September 8, 2002

To: T10 Technical Committee
From: Timothy Hoglund (LSI Logic)
Subject: SAS Expander update

This proposal is an update to SAS expander definition including a refinement of the Expander device model (section 4.8) and an update to the XL state machine (section 7.12.3).

Figure 1. Expander device model

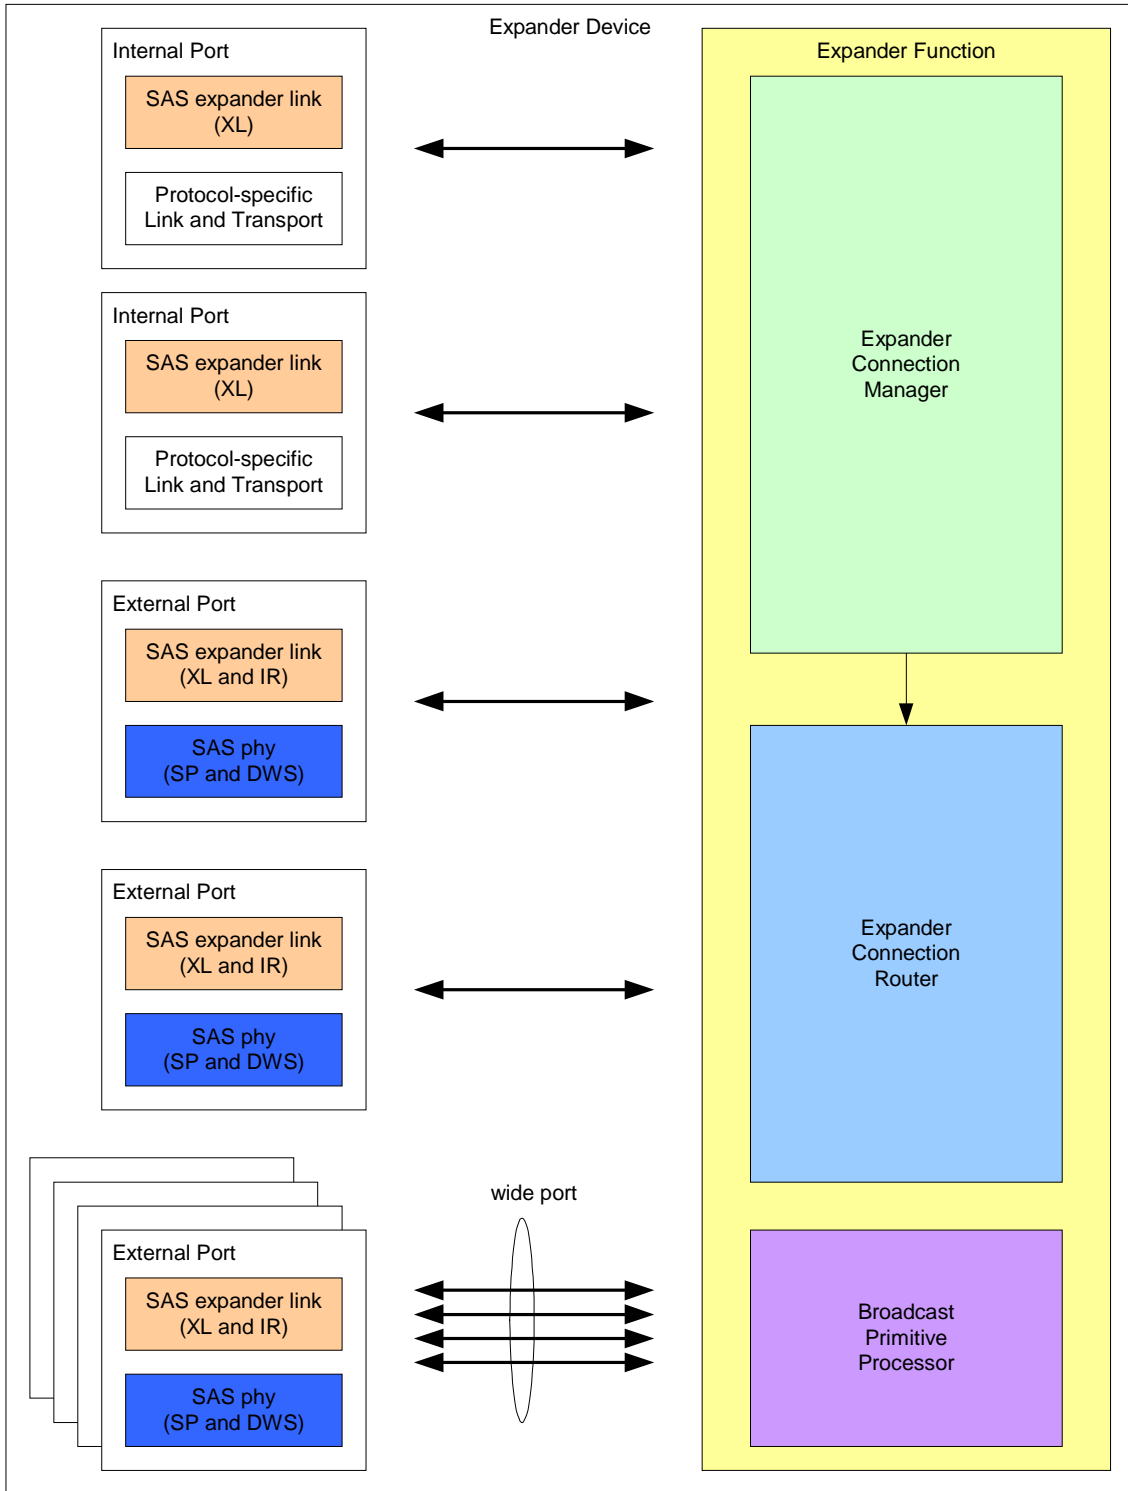
- 1) updated expander device model
- 2) move PPT timers from Expander Function to XL state machine
- 3) expander interface signal descriptions
- 4) updates to XL state machine

Figure 1 shows the model of an expander device.

An expander device shall contain the following components:

- a) two or more external expander ports;
- b) expander connection manager;
- c) expander connection router;
- d) broadcast primitive processor; and
- e) SMP target port.

Figure 2. Expander interfaces

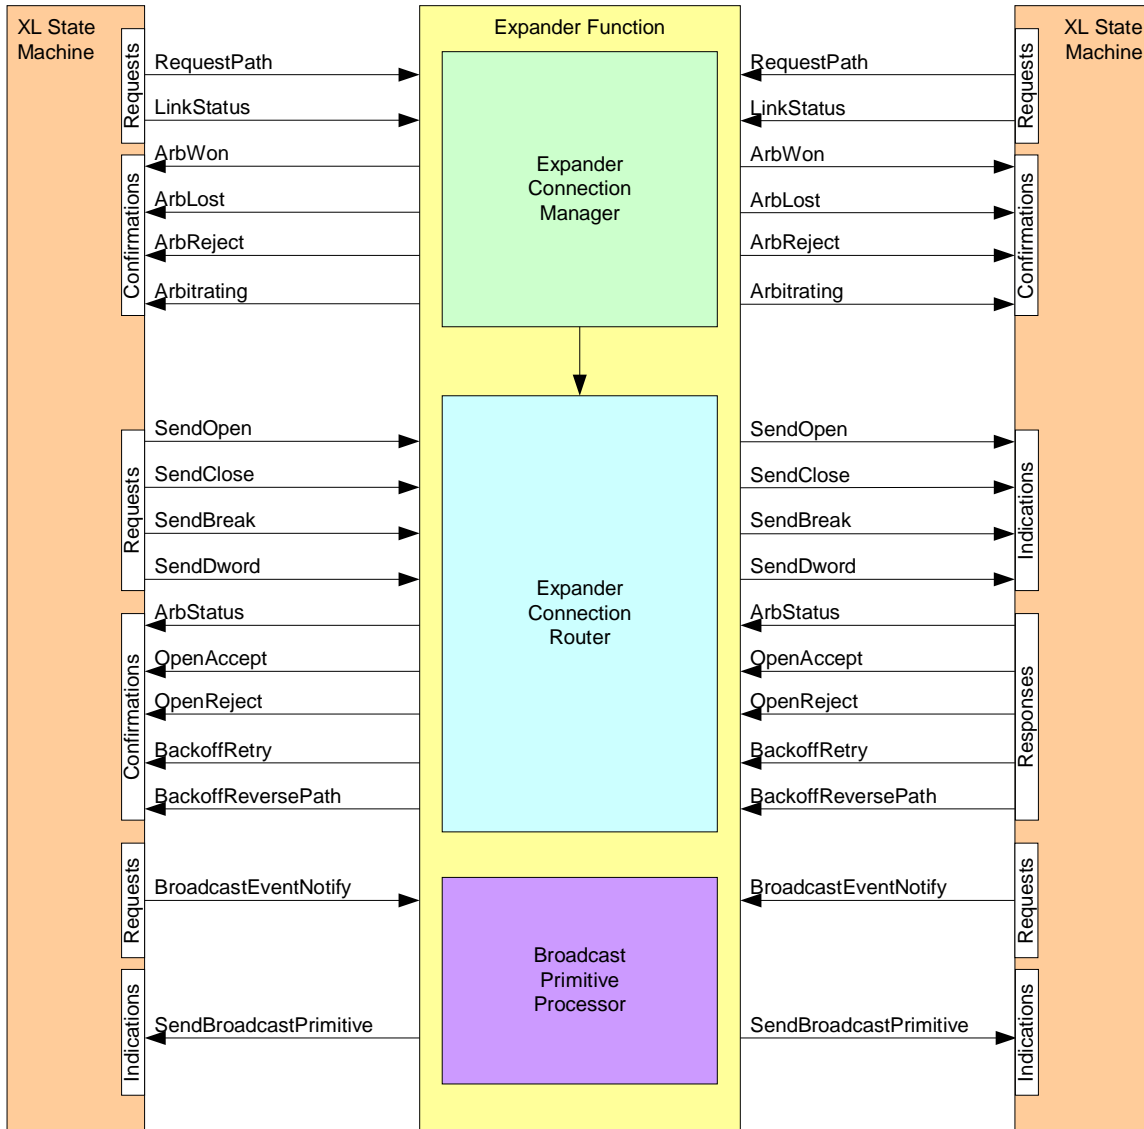
Figure 2 shows the interface requests, confirmations, indications, and responses used by an expander device to manage connections.

Figure 3. SAS Expander Connection state diagram

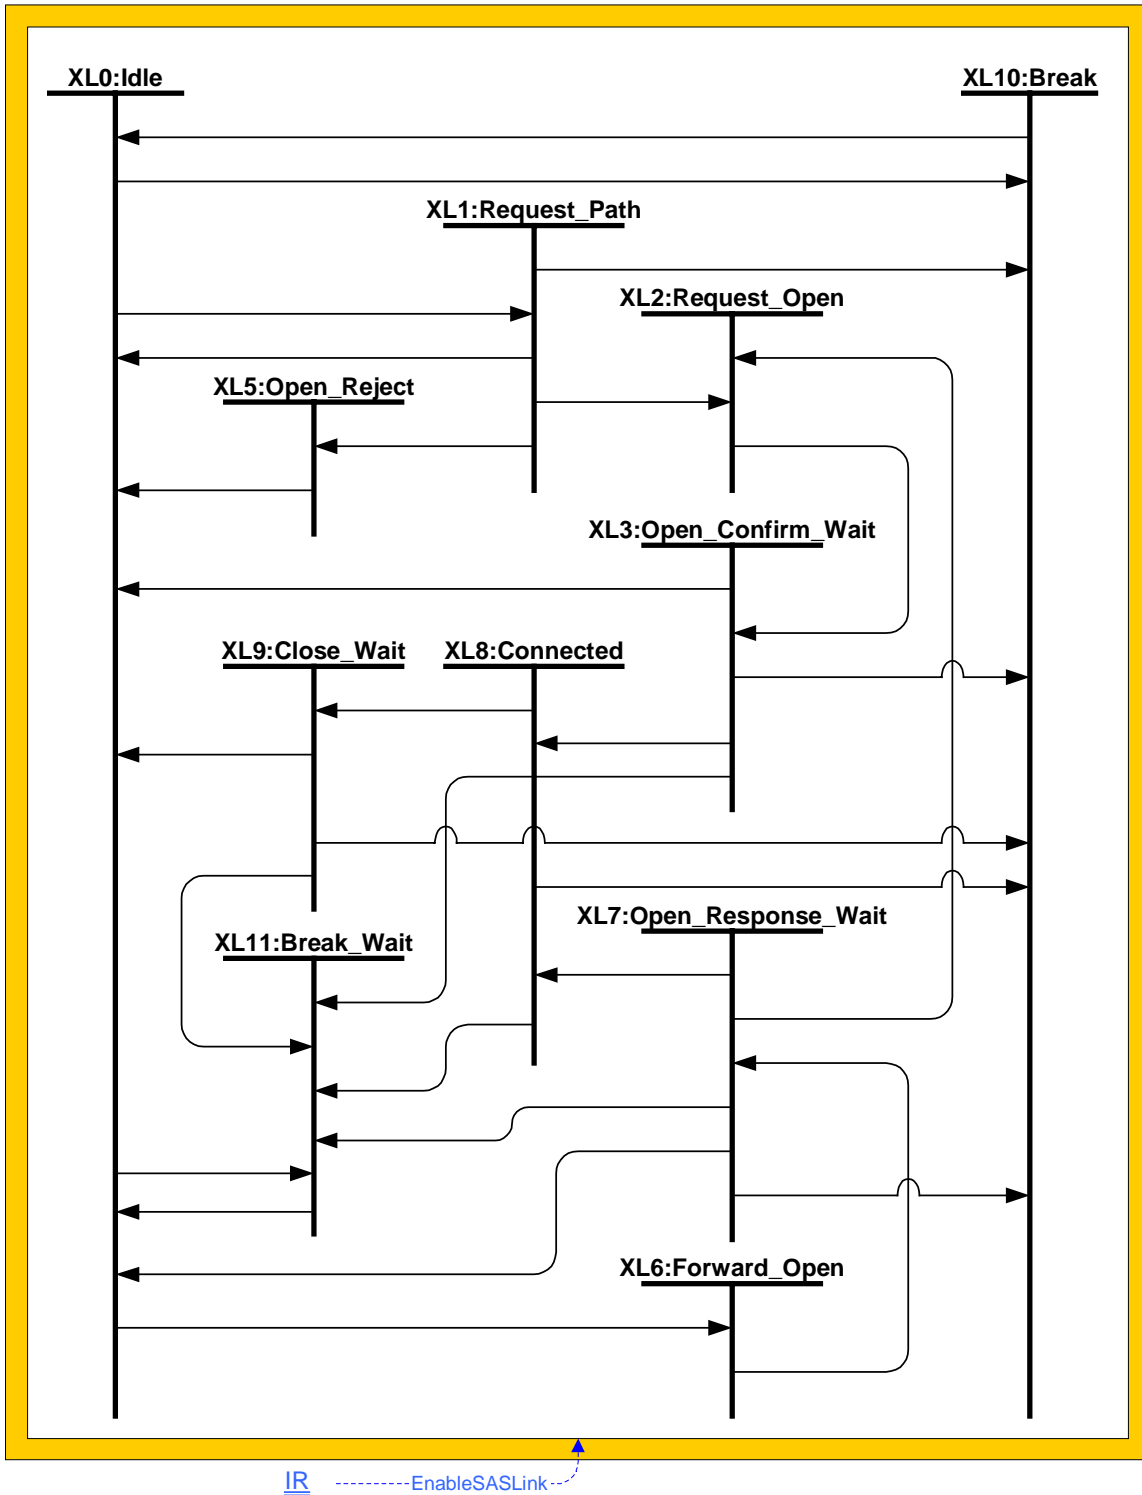
- a) XL0:Idle;
- b) XL1:Request_Path;
- c) XL2:Request_Open;
- d) XL3:Open_Confirm_Wait;
- e) ~~XL4:Open_Backoff;~~
- f) XL5:Open_Reject;
- g) XL6:Forward_Open;
- h) XL7:Open_Response_Wait;
- i) XL8:Connected;
- j) XL9:Close_Wait;
- k) XL10:Break; and
- l) XL11:Break_Wait.

[TEH: this transition is to cover BREAK received immediately after ArbLost case]

[\[TEH: should this be a 1,2,3 list with an else/otherwise for idle dwords? \]](#)

[TEH: enumerate OpenRejects ?]
